MWO 9-2320-272-20-6

FUEL TANK VENTILATION KIT
MODIFICATION WORK ORDER

MODIFICATION OF 5-TON
M939 AND M939A1 SERIES TRUCKS

FIGURE 1

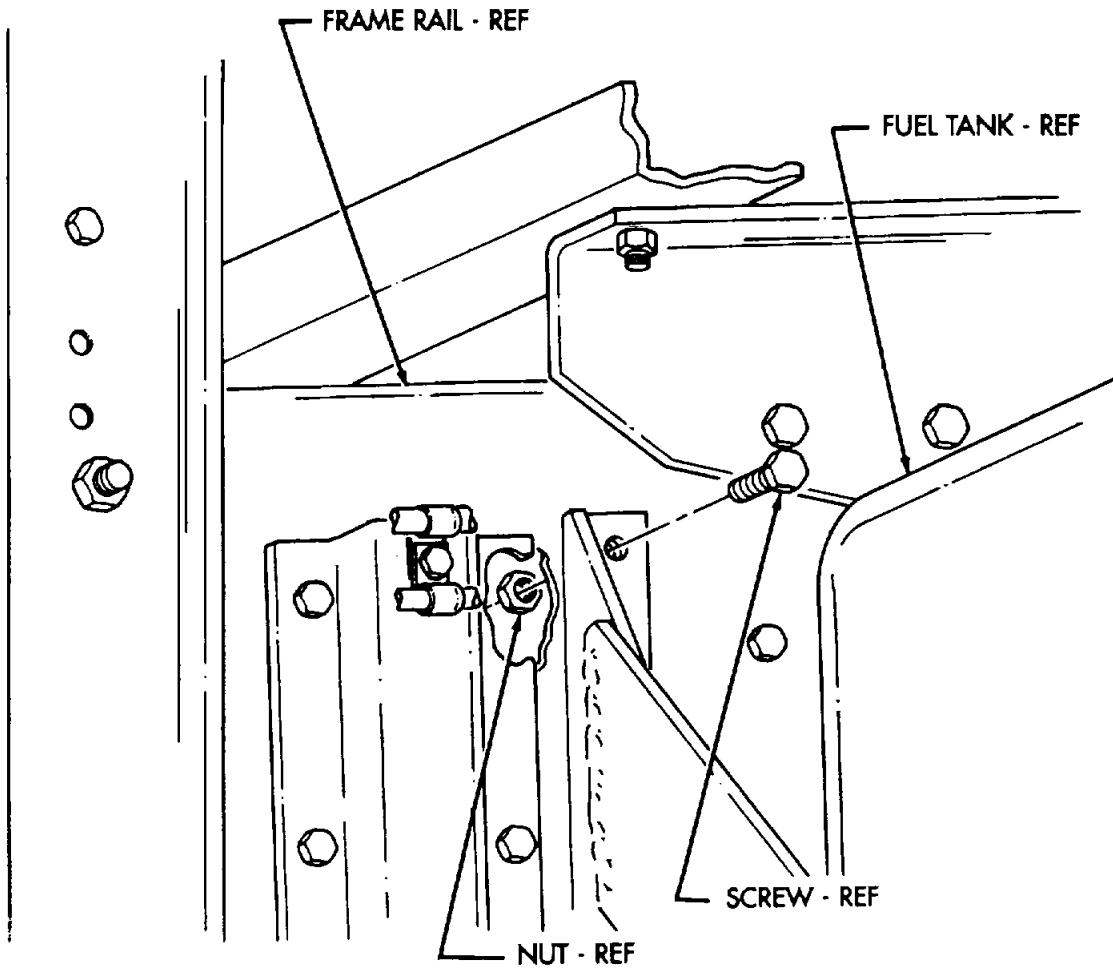
- (1) Disconnect battery ground cables (TM 9-2320-272-20-1).
- (2) Remove tachometer pulse sender unit (TM 9-2320-272-20-1).
- (3) Remove nut and screw from frame rail as shown in figure 1. Set nut and screw aside for disposition per para. 8.

FIGURE 2

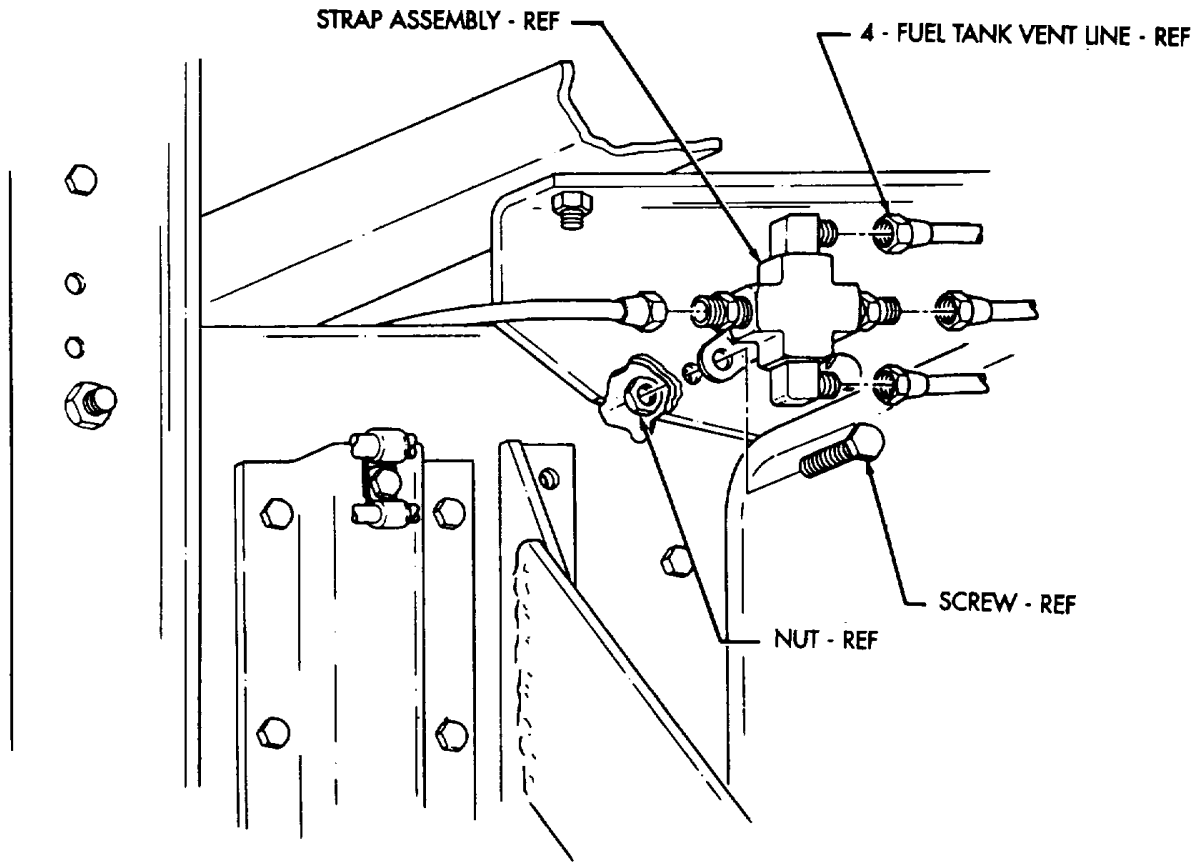
- (4) Disconnect four vent lines from strap assembly as shown in figure 2.
- (5) Remove nut, screw, and strap assembly from frame rail as shown in figure 2. Set nut, screw, and strap assembly aside for disposition per para. 8.

FIGURE 3

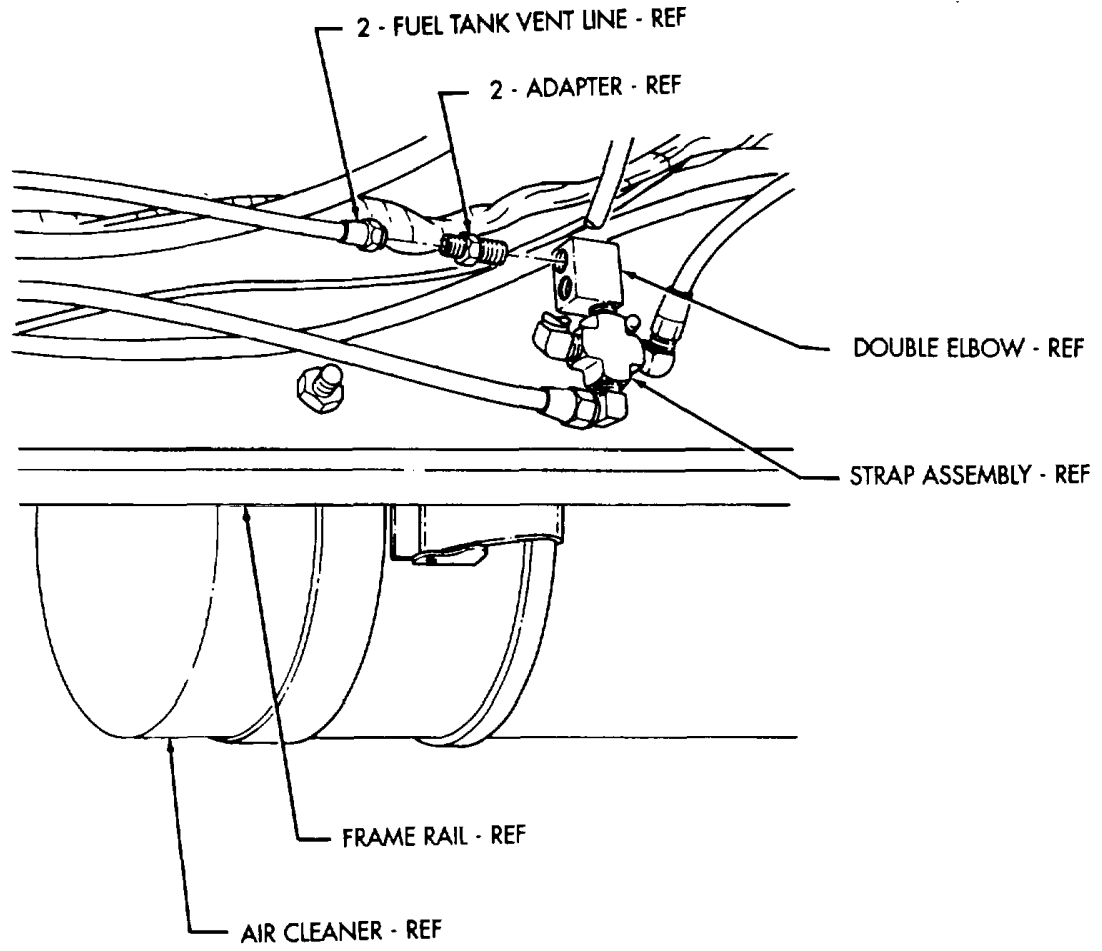
- (6) Remove two fuel tank vent lines and adapters from double elbow connected to strap assembly on inside frame of rail, opposite air cleaner as shown in figure 3. Set adapters aside for disposition per para. 8.
- (7) Remove two nuts, screws, and clamps from fuel return line and fuel supply line as shown in figure 4. Retain nuts, screws, and clamps for installation.

FIGURE 4

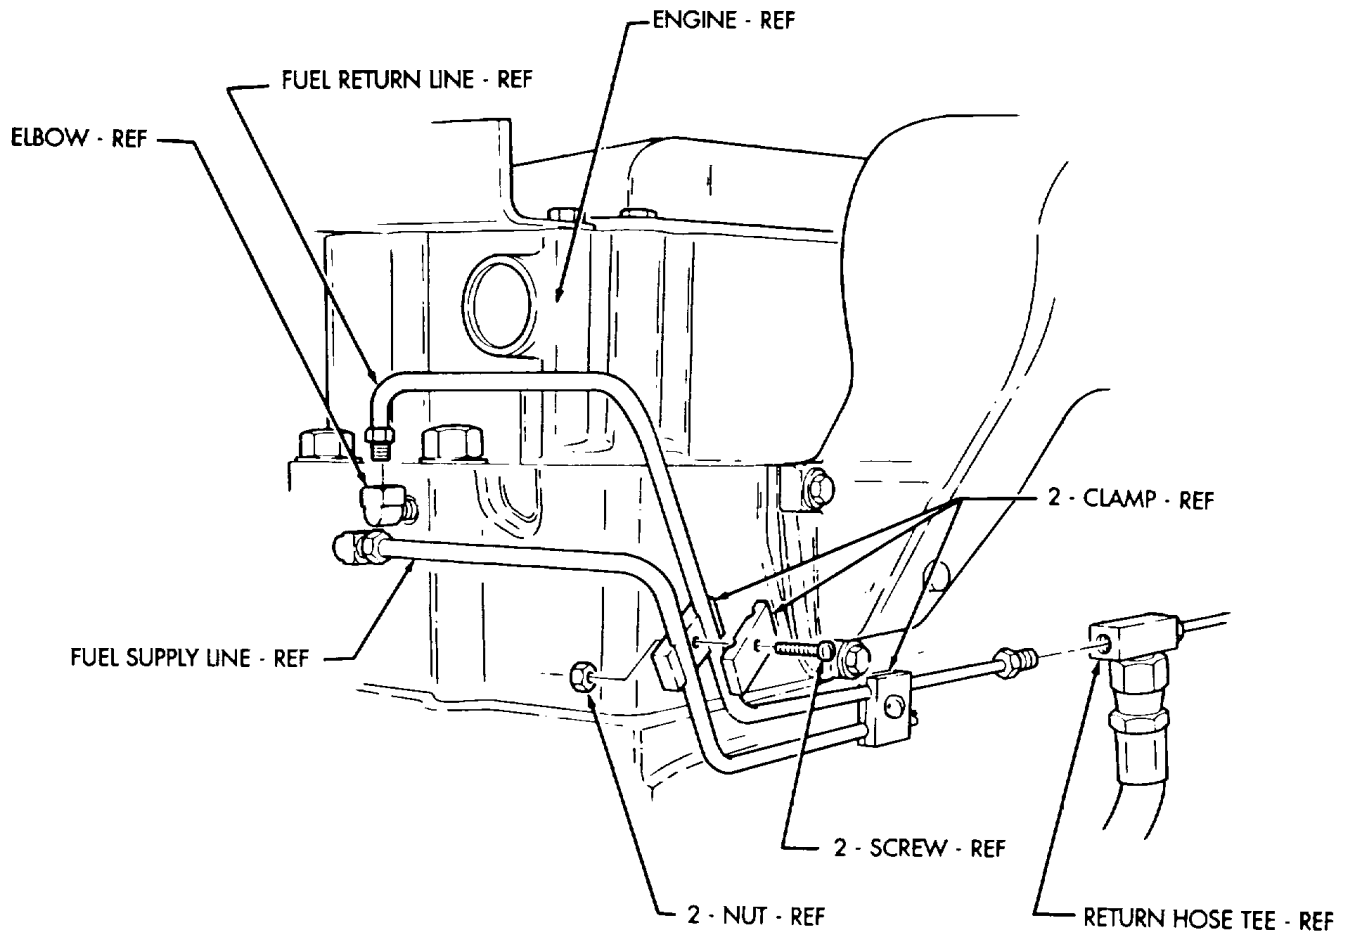
- (8) Disconnect fuel return line from return hose tee and elbow on front of engine as shown in figure 4.

FIGURE 5

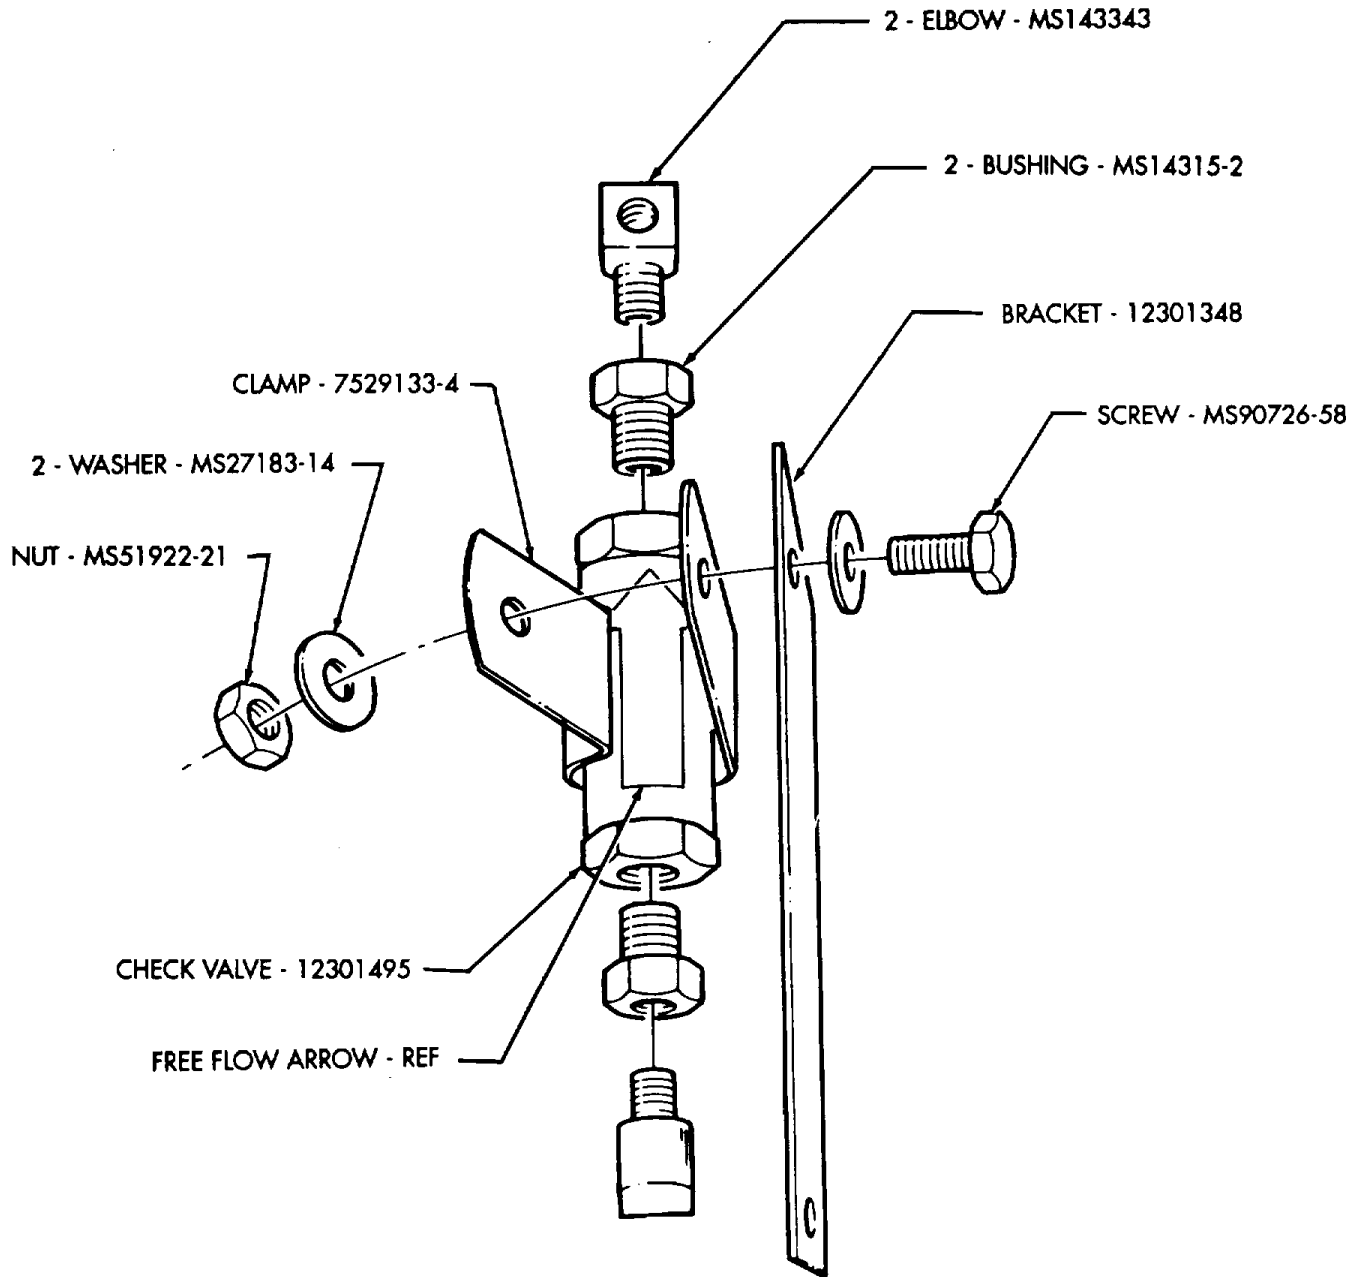
- (1) Install two MS14315-2 bushings in 12301495 check valve as shown in figure 5.

- (2) Install two MS143343 elbows on bushing as shown in figure 5.
- (3) Install 7529133-4 clamp on check valve as shown in figure 5.

Clamp must be installed on check valve with free flow arrow pointing up when installed on engine to prevent damage to internal engine components.

- (4) Install check valve on 12301348 bracket with MS90726-58 screw, two MS27183-14 washers, and MS51922-21 nut as shown in figure 5. Ensure free flow arrow on check valve points up.

FIGURE 6
14

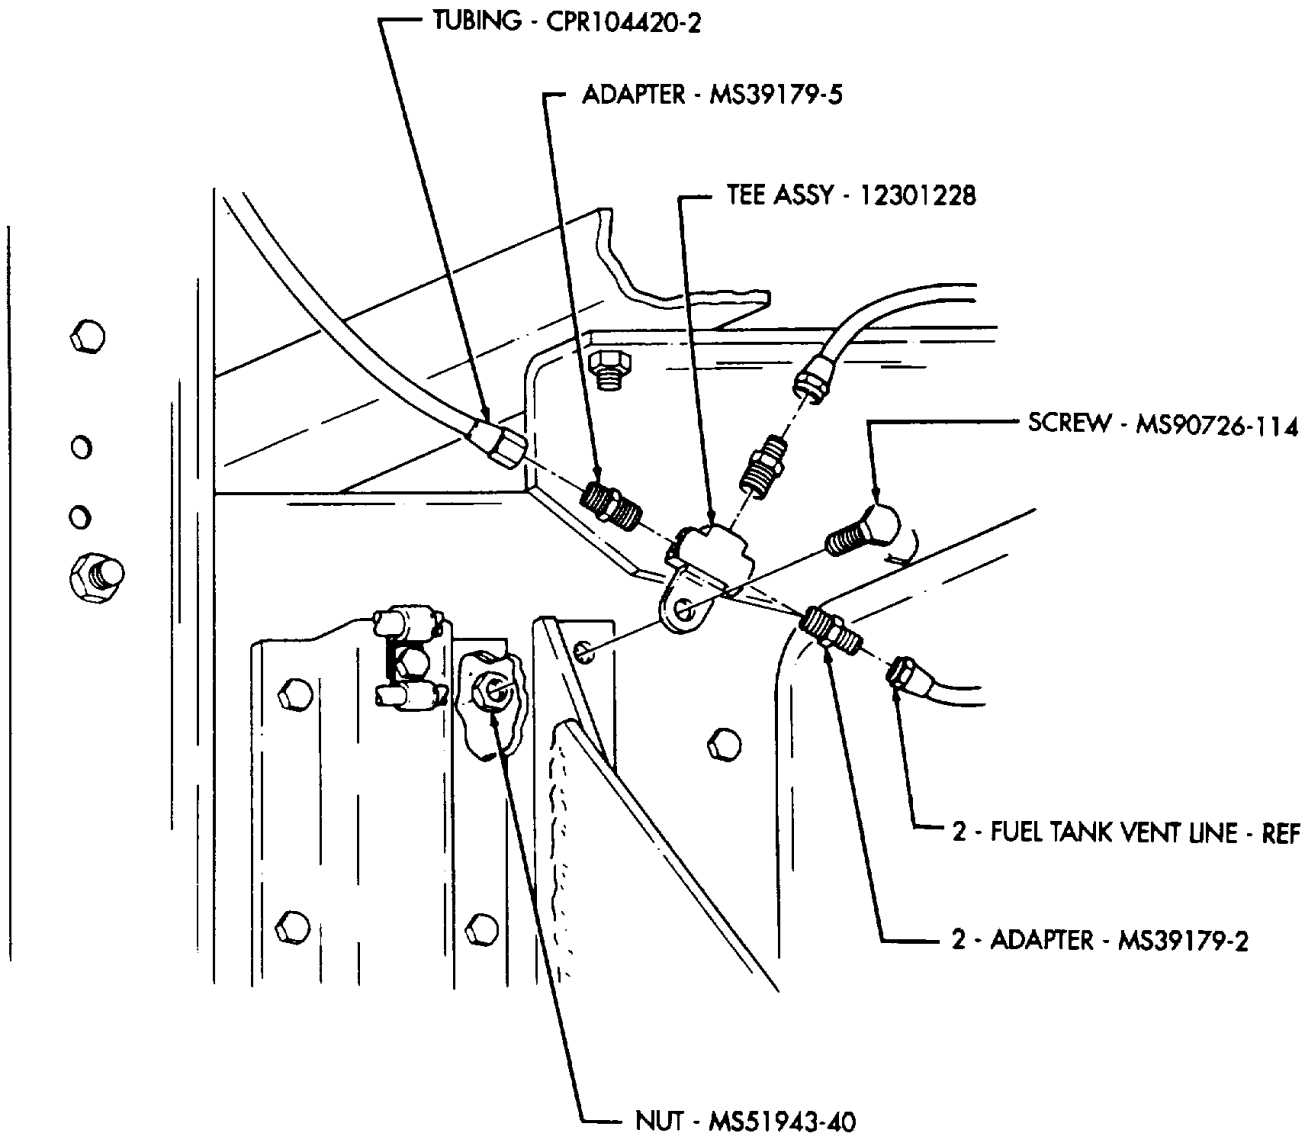
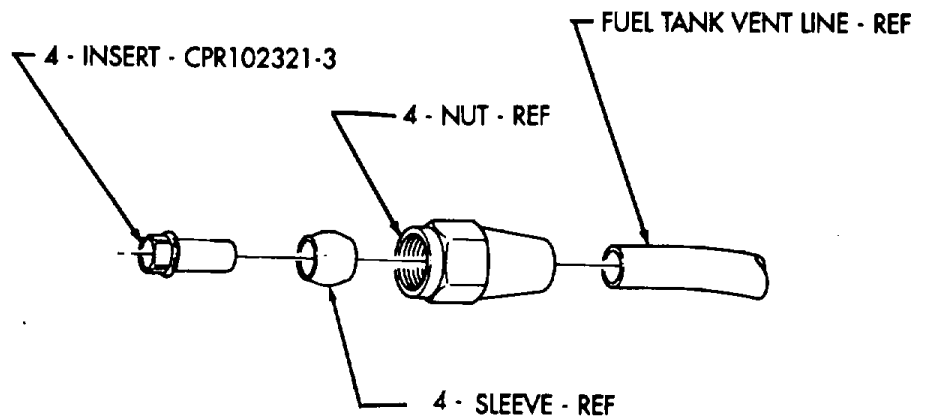
- (5) Install two MS39179-2 adapters on 12301228 tee assembly as shown in figure 6. Retain sleeves and nuts for installation.
- (6) Install two 12255985 double elbows on 12301228 tee assembly as shown in figure 7.

- (1) Install two MS20913-2 plugs in double elbow on strap assembly located inside of frame rail opposite air cleaner as shown in figure 10.
- (2) Install tee assembly on frame rail with MS90726-114 screw and MS51943-40 nut as shown in figures 6 or 7.

- (3) Connect two fuel tank vent lines from fuel tank-to-tee assembly as shown in figure 6.
- (4) Connect four fuel tank vent lines from fuel tanks-to-tee assembly as shown in figure 7.
- (5) Connect end of CPR104420-2 fuel tank vent line to tee assembly (12301228) as shown in figures 6 or 7.
- (6) Install tube (12301244) on air intake pipe with four MS35842-16 clamps as shown in figure 11. Remove excess clamp ends.
- (7) Connect end of fuel tank vent tubing (CPR104420-2) to tube (12301244) as shown in figure 11.

FIGURE 7

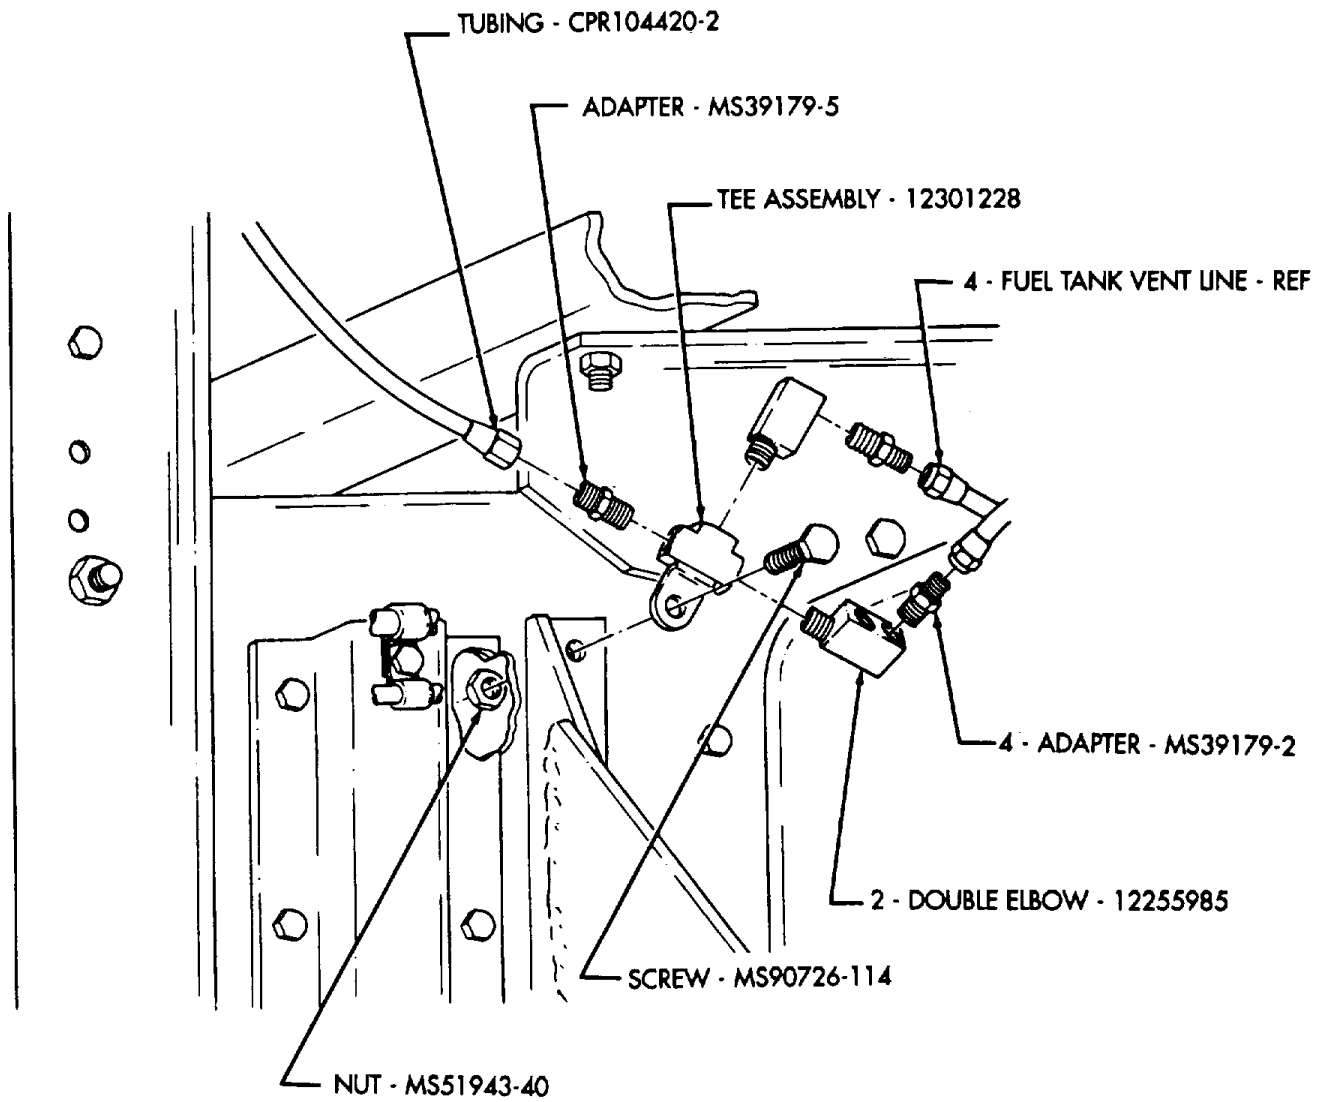
- (7) Install four MS39179-2 adapters on two double elbows as shown in figure 7.
- (8) Install MS39179-5 adapter on tee assembly as shown in figures 6 and 7. Retain sleeve and nut for use in step 12.

- Perform step (3) for vehicles equipped with single fuel tank.
- Perform step (4) for vehicles equipped with dual fuel tanks.
- If vent lines must be cut and shortened, use new nuts, sleeves, and CPR102321-3 inserts as shown in figure 7.
- Four CPR102321-3 inserts are required for vehicles equipped with dual fuel tanks.
